**Montrose Technical Responses to  
EPA Comments dated January 27, 2010 on the  
DNAPL Feasibility Study dated April 21, 2009**

## FIGURE 1 CHLOROBENZENE BELLFLOWER SAND, APRIL 2009

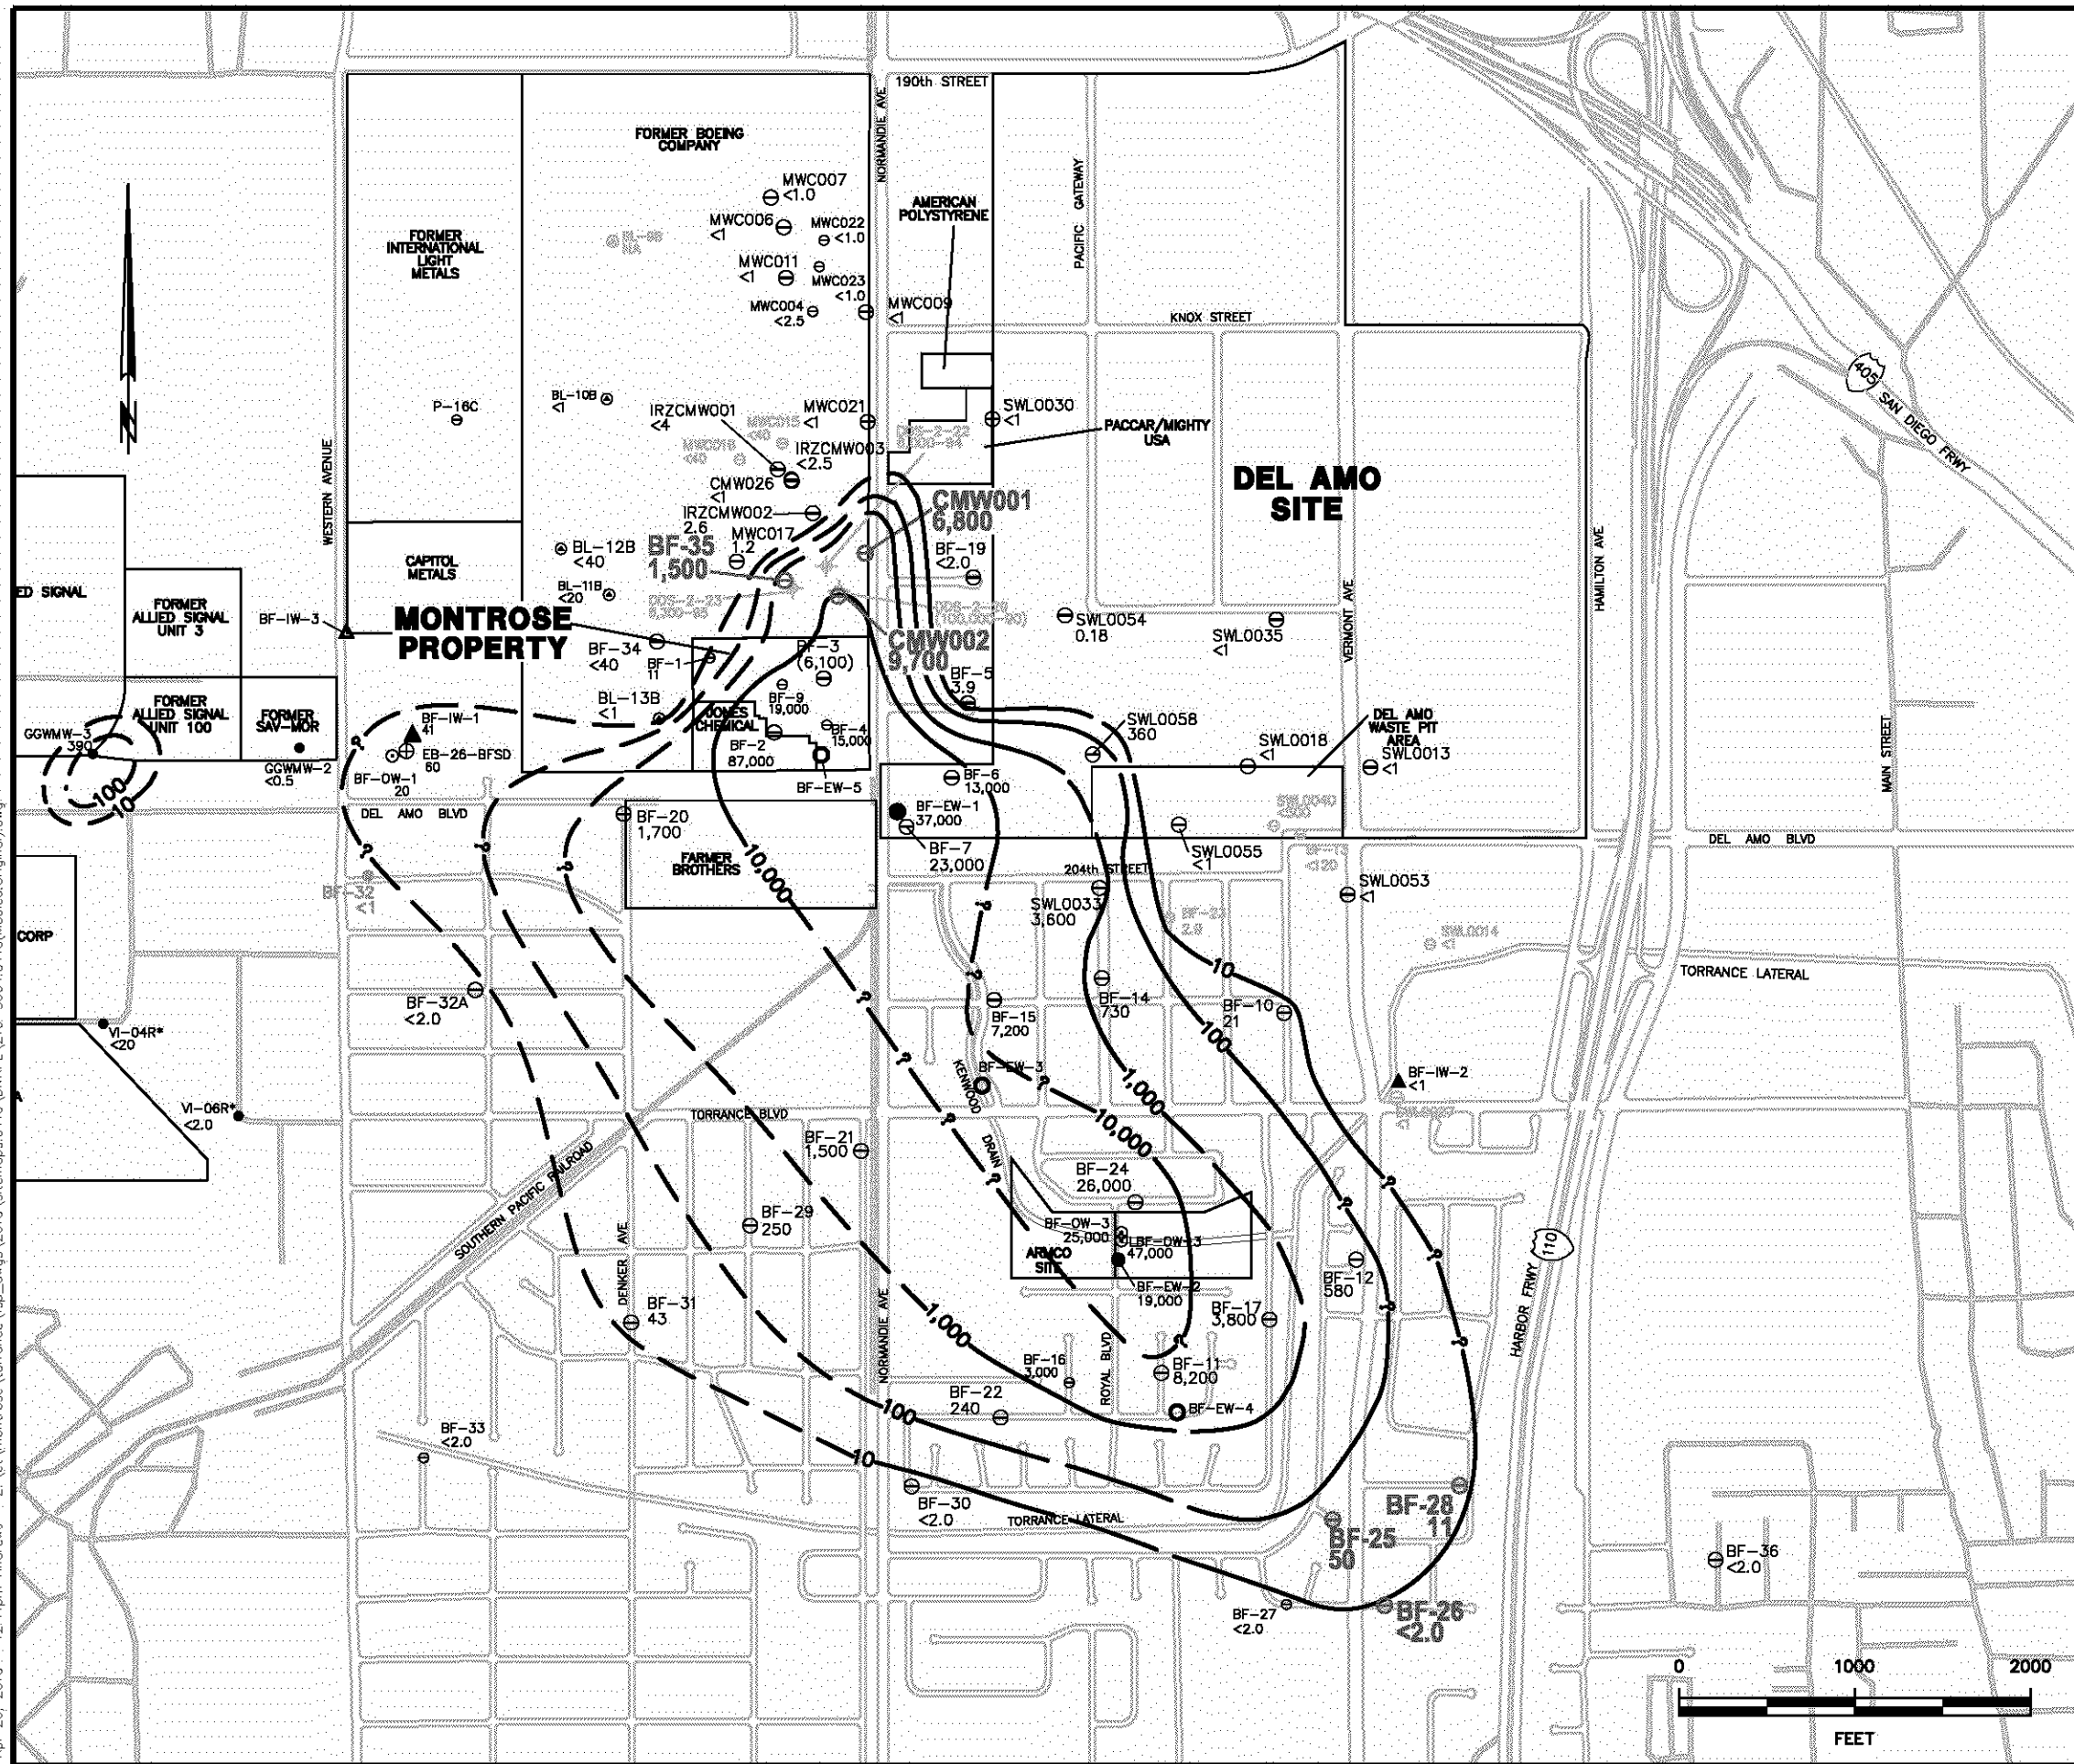
*Downgradient: "According to Table 3 of this report, well BF-28, at the southeastern toe of the plume, increased in chlorobenzene concentration from <1.0 on March 2, 2006, to 58 µg/l in October 2006. The previous high chlorobenzene concentration in this well was 5 µg/l. The p-CBSA concentration in this well in October 2006 was 1,200 µg/l. Thus, significant amounts of chlorobenzene, approaching the groundwater cleanup concentration of 70 µg/l, have reached this well in the last couple years. This indicates that the dissolved phase plume is expanding in the downgradient direction in the Bellflower Sands."*

*Downgradient:* Montrose does not agree with EPA's evaluation of the downgradient groundwater monitoring data in the Bellflower Sand (BFS). EPA has not considered the April 2009 result from well BF-28, where MCB was detected at a concentration of 11 ug/L. The April 2009 result is approximately five times lower than the October 2006 result and approximately seven times lower than the groundwater cleanup goal established in the Record of Decision (ROD). The concentration of MCB in BF-28 has decreased over the last 3 years and the concentration trend in this well does not suggest that the MCB plume is expanding downgradient. The April 2009 results were reported to EPA in a document entitled *Supplemental Groundwater Sampling and Analysis Results, April 2009, Montrose Superfund Site, Los Angeles, California* (H+A, 2009).

**Figure 3**  
**MCB Concentrations North of the Montrose Property in the BFS**  
**Montrose Superfund Site**

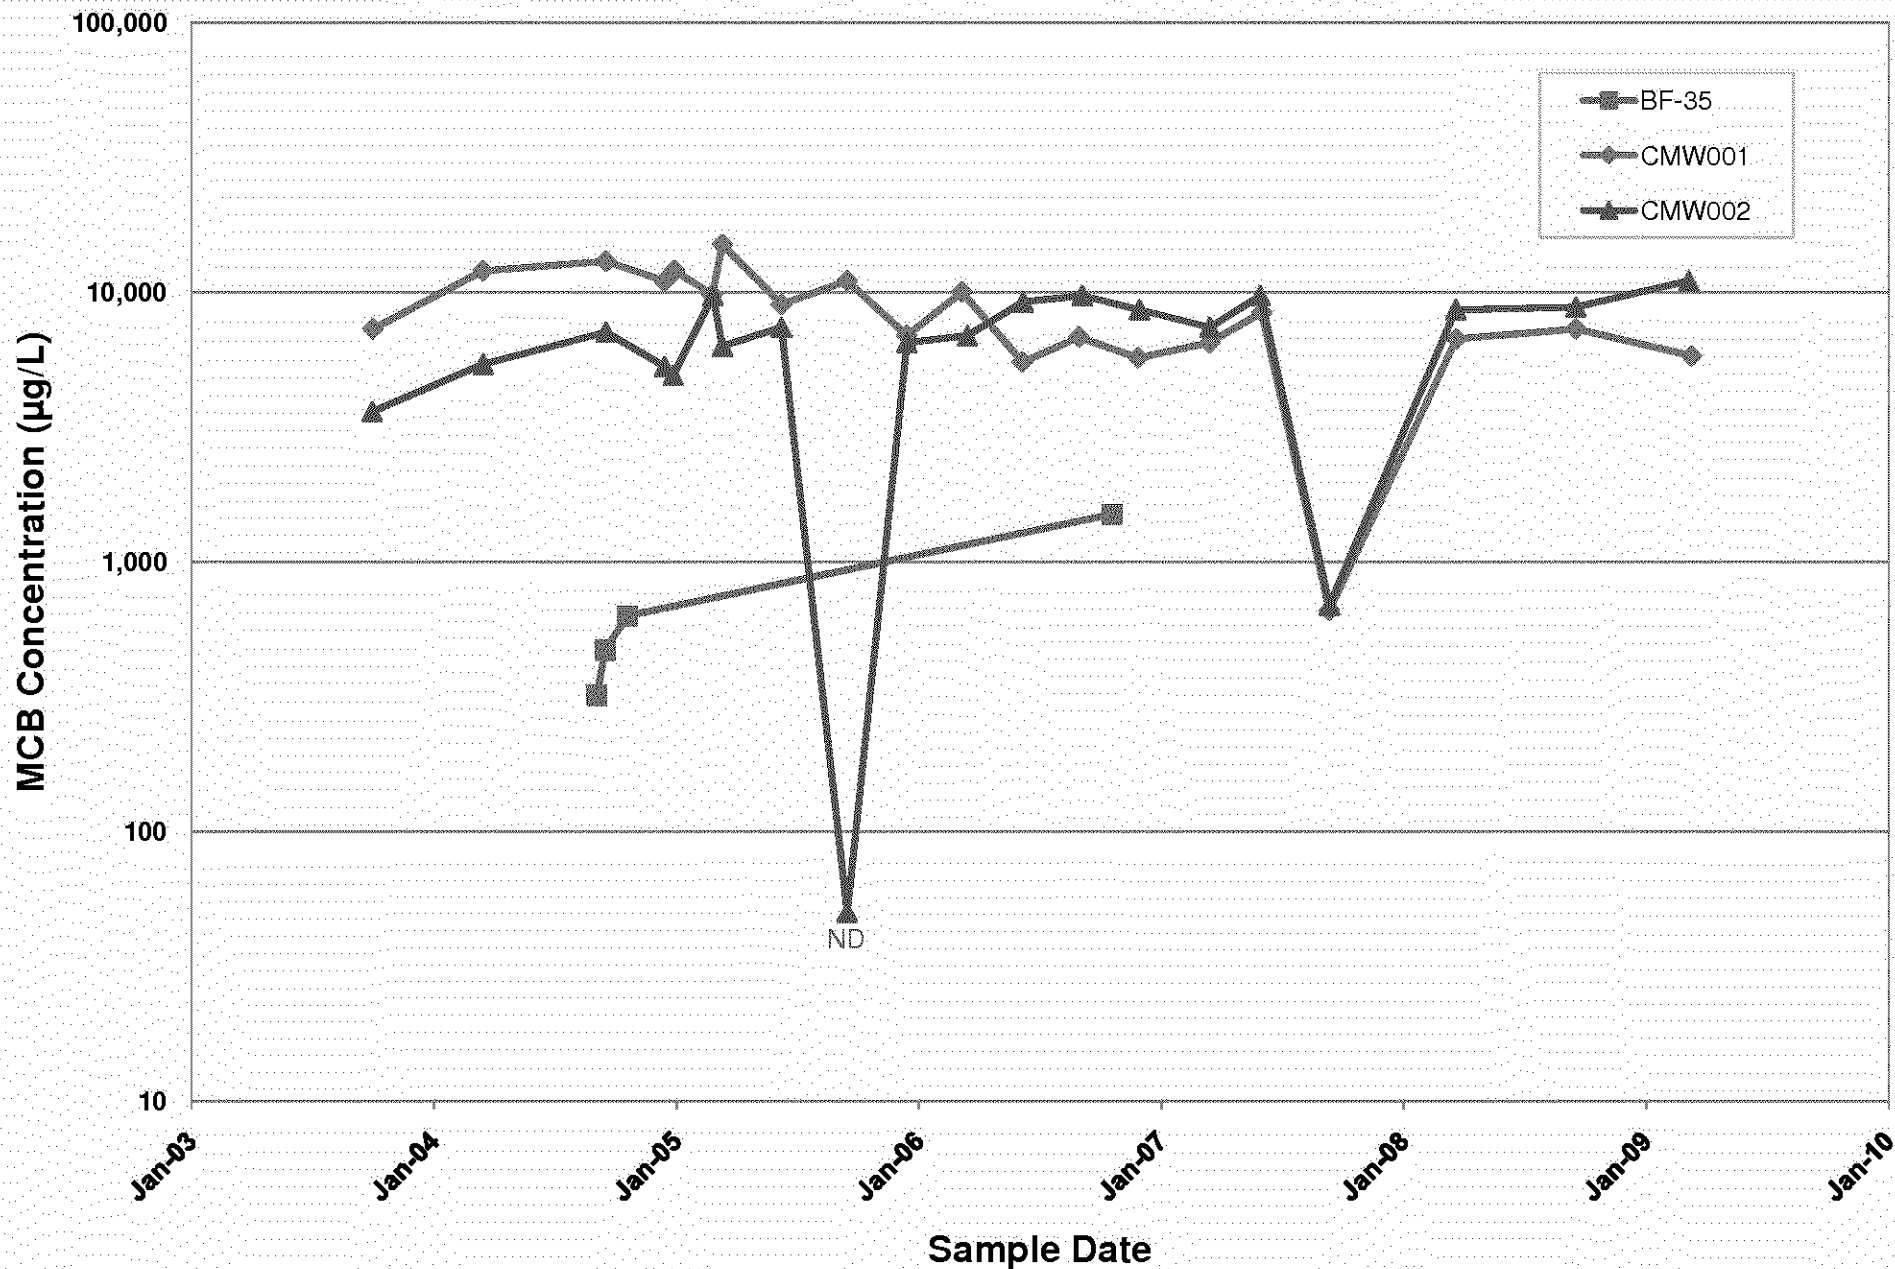
*Upgradient: "Monitoring well BF-35, which is located approximately 200 feet north of the Montrose property, showed an increase in chlorobenzene concentration from 630 µg/l on October 26, 2004, to 1,500 µg/l in October 2006, and a p-CBSA concentration of 6,800 µg/l in October 2006. Another well in this area, CMW001, also had a chlorobenzene concentration of 6,000 µg/l in October 2006. The increases in chlorobenzene concentration in the up gradient groundwater direction is unexpected, and it appears that DNAPL is moving to the north from the site under the former Boeing property. Given these high concentrations, it is likely the DNAPL extends up gradient (further to the north) of these wells. Small concentrations of DDT were also found in the Bellflower sands to the north of the CPA (FS, page 2-15)."..."Based upon these findings, EPA is concerned that DNAPL may already be migrating outside of the containment zone."*

Upgradient: Montrose does not agree that an increasing dissolved MCB concentration trend is due to DNAPL migration within the BFS or that the DNAPL migration is approaching the TI Waiver Zone boundary. There are three BFS monitoring wells located within the dissolved MCB plume north of the Montrose Property including BF-35, CMW001, and CMW002. The MCB concentration trends in these three wells are plotted in **Figure 3** and summarized as follows:

- Well BF-35: The MCB concentration has increased from 320 ug/L in September 2004 to 1,500 ug/L in October 2006, as indicated by EPA.
- Well CMW001: The MCB concentration increased from 7,300 ug/L in October 2003 to a peak of 15,000 ug/L in March 2005 but has since declined to 5,800 ug/L in March 2009.
- Well CMW002: The MCB concentration increased from 3,600 ug/L in October 2003 to 9,700 ug/L in March 2005 and has remained relatively stable since that time. In March 2009, the MCB concentration in this well was 11,000 ug/L.

CMW001 is located near the TI Waiver Zone boundary but has been exhibiting a declining MCB concentration trend since March 2005. BF-35 and CMW002 are located south of the TI Waiver Zone boundary, and CMW002 has been exhibiting a relatively stabilized MCB concentration trend since 2005. An increasing MCB concentration trend is occurring at BF-35, but Montrose disagrees that DNAPL migration to the north within the BFS is the cause for the following reasons:

**Figure 4**  
**Montrose Superfund Site MCB Mass**  
**Initial Conditions**

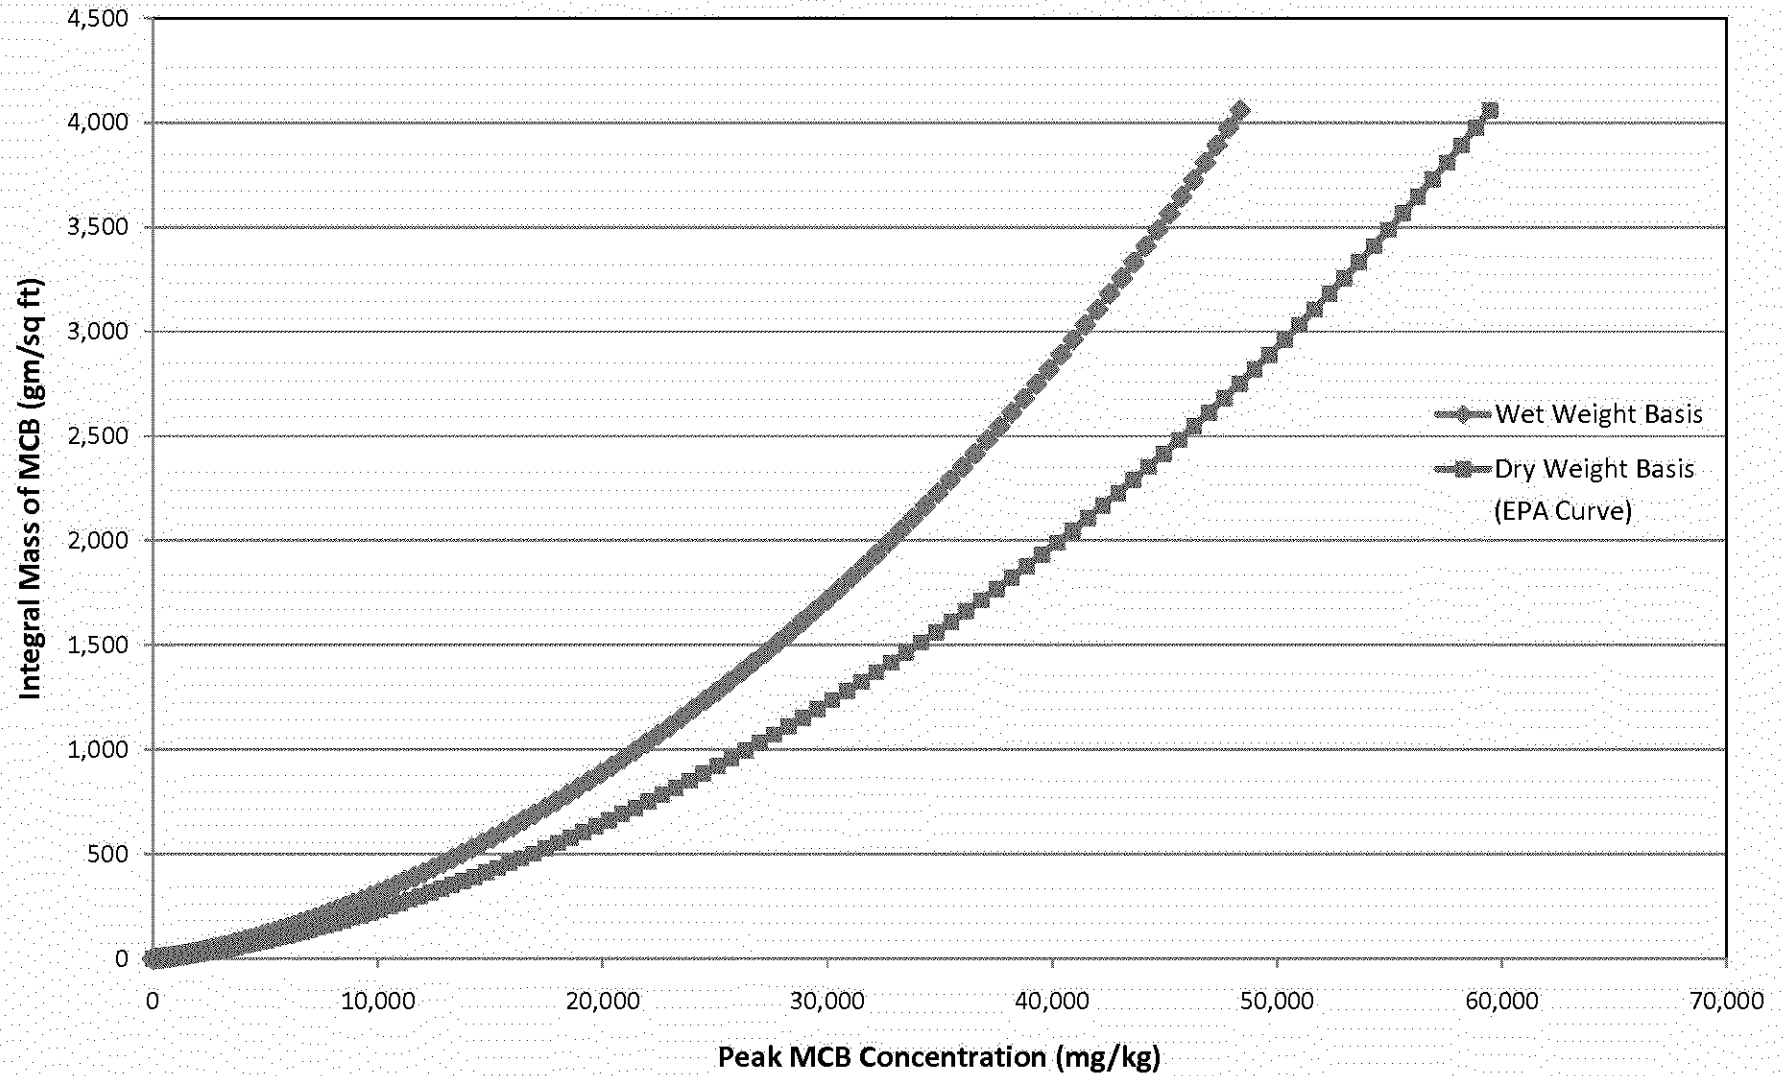
*DNAPL Mass in the UBA: In Specific Comment No. 4, titled DNAPL Mass in the Saturated Zone is Overestimated, EPA indicates that... "For the overall DNAPL area, this approach results in an estimate of MCB mass of 291,000 pounds (lbs) (582,000 lbs of DNAPL), which is smaller than, but not grossly different from the estimate of 398,000 lbs of MCB (796,000 lbs of DNAPL) provided in the FS.*

*In Specific Comment No. 4, EPA indicates that... "Throughout the Montrose property, the FS estimates the mass of mobile MCB to be 111,000 lb (222,000 lbs of DNAPL), which appears to be an overestimate of mobile DNAPL and MCB. The alternate approach used by EPA produces an estimate of 40,000 lbs of mobile MCB (80,000 lbs of DNAPL), which is less than half of that estimated in the FS."*

**Corrected DNAPL Mass Integral:** Although the 2-D bench testing results were reported on a dry weight basis, the DNAPL Reconnaissance Investigation samples were analyzed on a wet weight basis using modified EPA Method 8270C. The peak MCB concentration detected at each DNAPL investigation boring was used to estimate DNAPL mass as shown in Appendix E of the DNAPL FS. EPA used the wet weight MCB concentrations from Table E-2 and a dry weight soil density, resulting in an erroneously low estimate of DNAPL mass. A corrected DNAPL mass integral (in grams per square foot) versus MCB concentration is presented in **Figure 4** along with EPA's mass integral curve. The impact of the soil density error is low at low DNAPL concentrations but increases at increasing DNAPL concentrations (diverging curves). A comparison of the DNAPL mass integrals for the two soil densities is provided as follows:

**Focused Treatment Area:** EPA assumed a focused treatment area of 30,492 square feet to estimate DNAPL mass, which is not correct. The size of the focused treatment area was defined as 26,000 square feet as indicated in Section 5.1.5 and shown in Figure 5.11 of the DNAPL FS. The size of the focused treatment area was based on DNAPL concentrations exceeding 53,000 mg/kg, which is equivalent to a residual DNAPL saturation of 18.9% on a wet weight basis. EPA's focused treatment area is 17% larger and is based on DNAPL concentrations exceeding 50,000 mg/kg or 17.9% residual DNAPL saturation. The larger area used by EPA resulted in an overestimation of the DNAPL mass within the focused treatment area.
